client:
Simon Payne & Caroline Hayes

architect:
WILLOW
DESIGN PLANNING DELIVERY

issued for:
APPROVAL

drawing title:
Proposed Elevations

0 0.5 1.0 2.0 3.0 4.0 5.0
Scale in metres

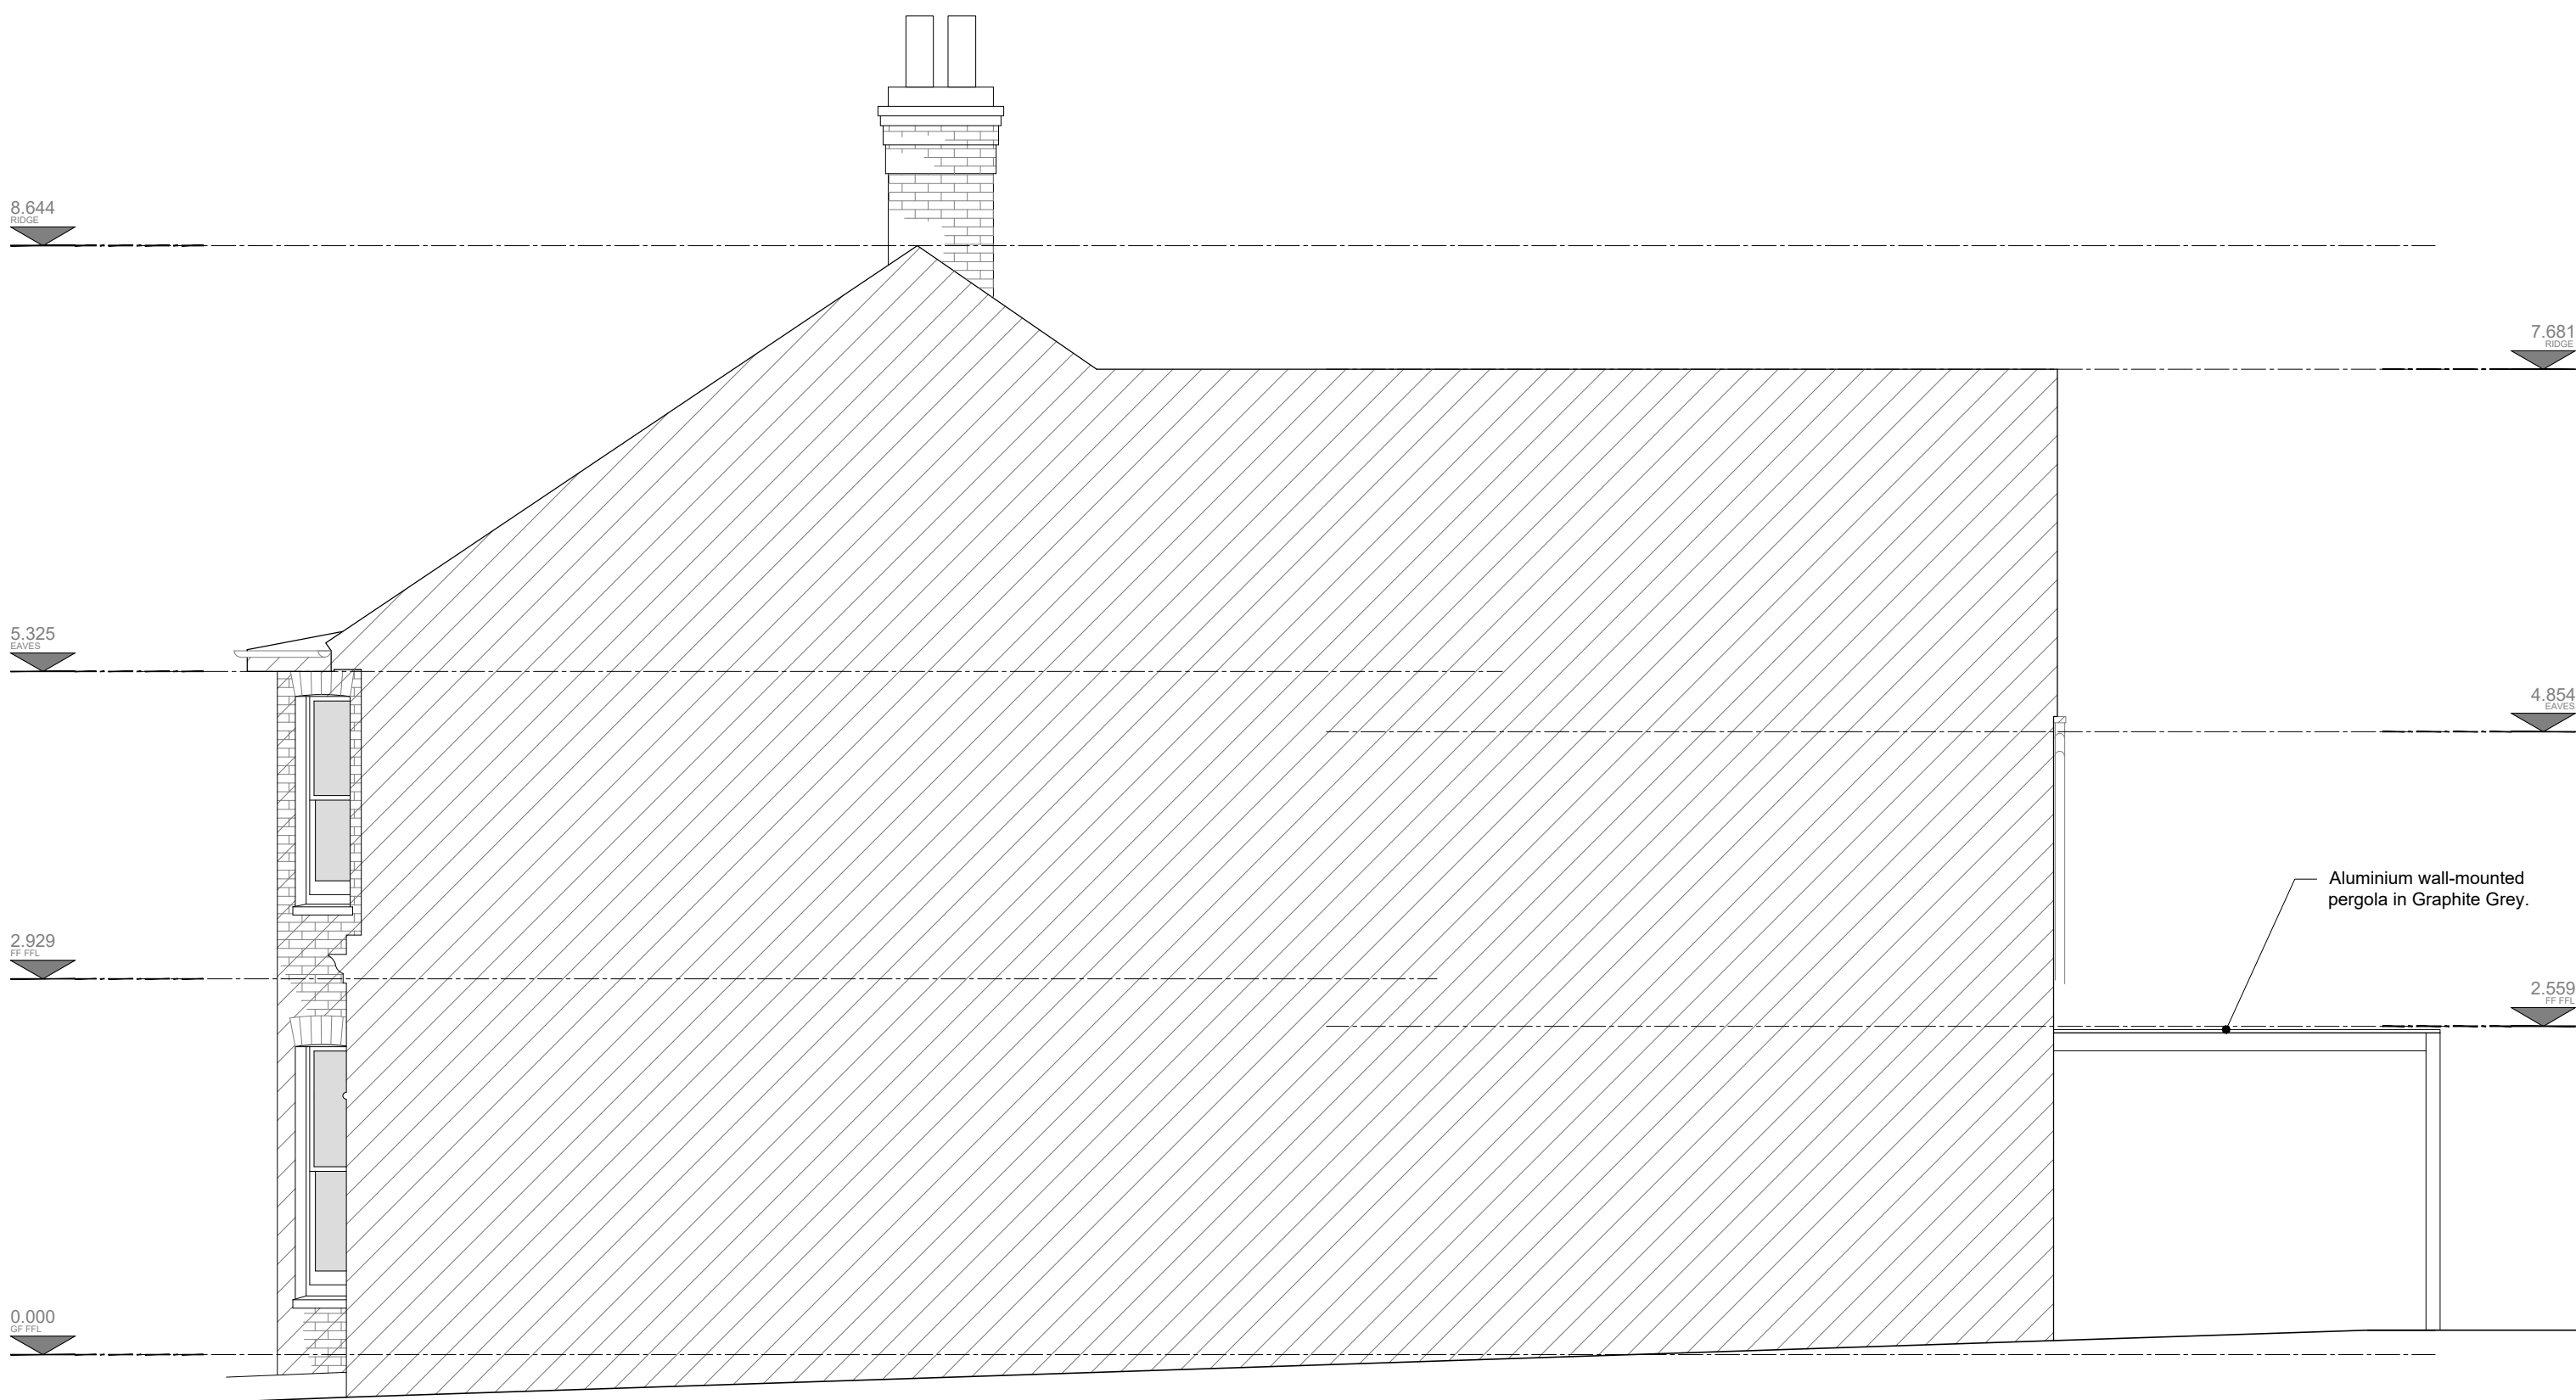
C	02/10/2026	Issued for approval. Variation of condition for french doorset into single door leaf.	SP	LH
B	05/06/2026	Revision in red clouds. Issued for approval. Revised to reflect the latest scope.	SP	LH
A	12/05/2026	Issued for approval.	SP	LH
/	18/03/2026	Issued for information.	SP	LH
